**BCA ASSESSMENT REPORT
SMALLS ROAD SCHOOL DEVELOPMENT**

Ref.: 160339

Smalls Road School Development

Blackett Maguire + Goldsmith Pty Ltd have been engaged to undertake an assessment of the DA design documentation for the proposed development at Smalls Road, Ryde, being the site of the prior Ryde High School against the requirements of the Building Code of Australia 2016 (BCA).

Figure 2: Site Plan

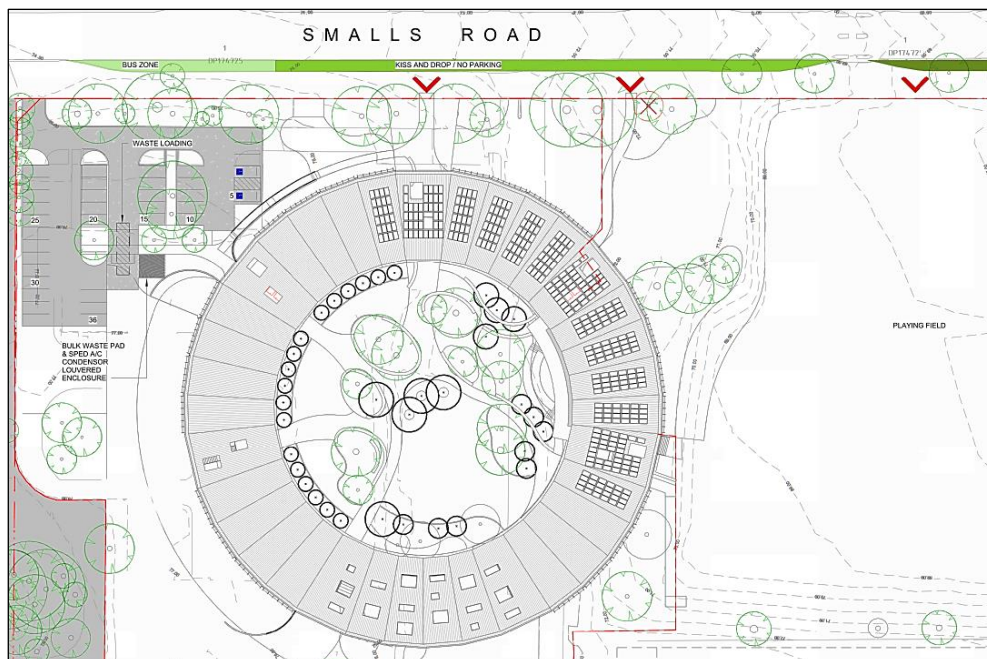
BOUNDARY	DISTANCE TO FIRE SOURCE FEATURE
North East	>6m to the Canteen Building
North West	0m to the allotment boundary adjoining the play field (confirmation of this boundary is to be confirmed)
South East	>6m to the far side of Lavarack Road
South West	>3m to the allotment boundary (the louvered enclosure is a Class 10a structure and as such is not a fire source feature)
